From: Franzone, Steve <Steve.Franzone@fpl.com>
Sent: Tuesday, February 14, 2017 3:49 PM
To: Comar, Manny
Cc: TurkeyCOL Resource; Hoellman, Jordan; Maher, William; Orthen, Richard
Subject: [External_Sender] ITAAC review
Attachments: PageC-343_from Turkey Point Unit 6 COL Appendix C-2.pdf; PageC-505_from Turkey Point Unit 6 COL Appendix C.pdf; LCB_4_from PART_10.pdf; PageC-341_from Turkey Point Unit 6 COL Appendix C-3.pdf

We have reviewed the draft ITAAC and have identified several potential editorials items:

Turkey Point Units 6 & 7
COL Application
Part 10 — License Conditions and ITAAC

**Figure 2.6.1-1 (Sheet 1 of 4)
Main ac Power System**

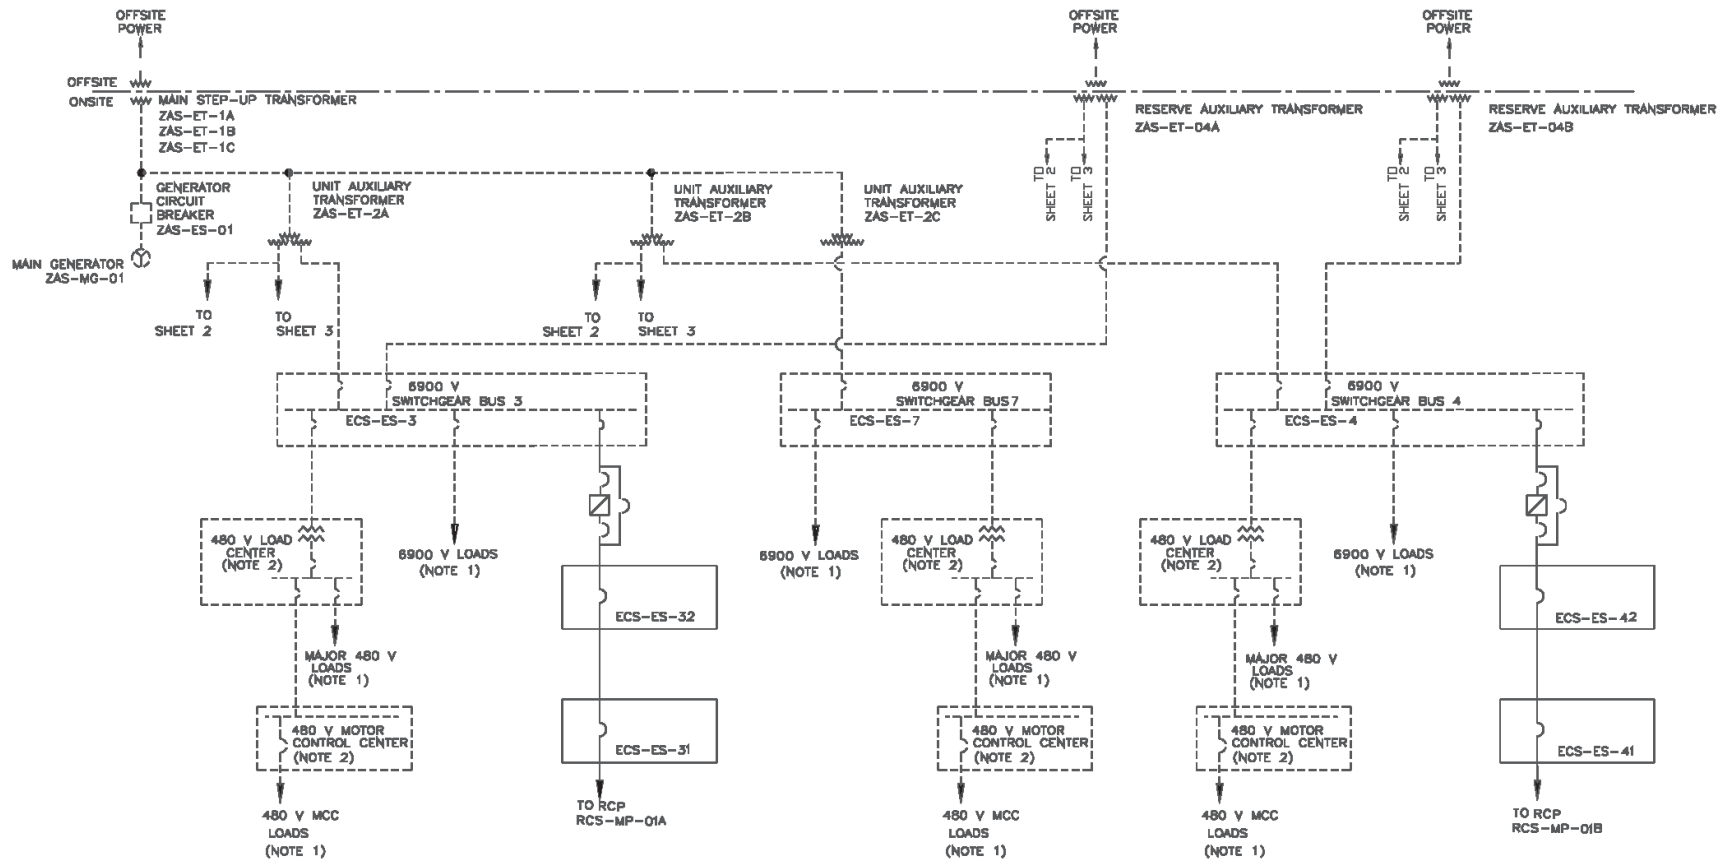
1. Figure 2.6.1-1 (sheet 1 of 4) missing "m" in System, page C-343,
2. Table 2.3.8-4, C.3.8.04.01 - extra "mudmat" removed as compared to our submittal. Page C-505,
3. Table 2.6.1-4, We had identify an Item 4. g) (ref COLA, PART 10 LCB-4) which was to be inserted as a result of NRC bulletin 2012-01 which appears to be missing, page C-341.
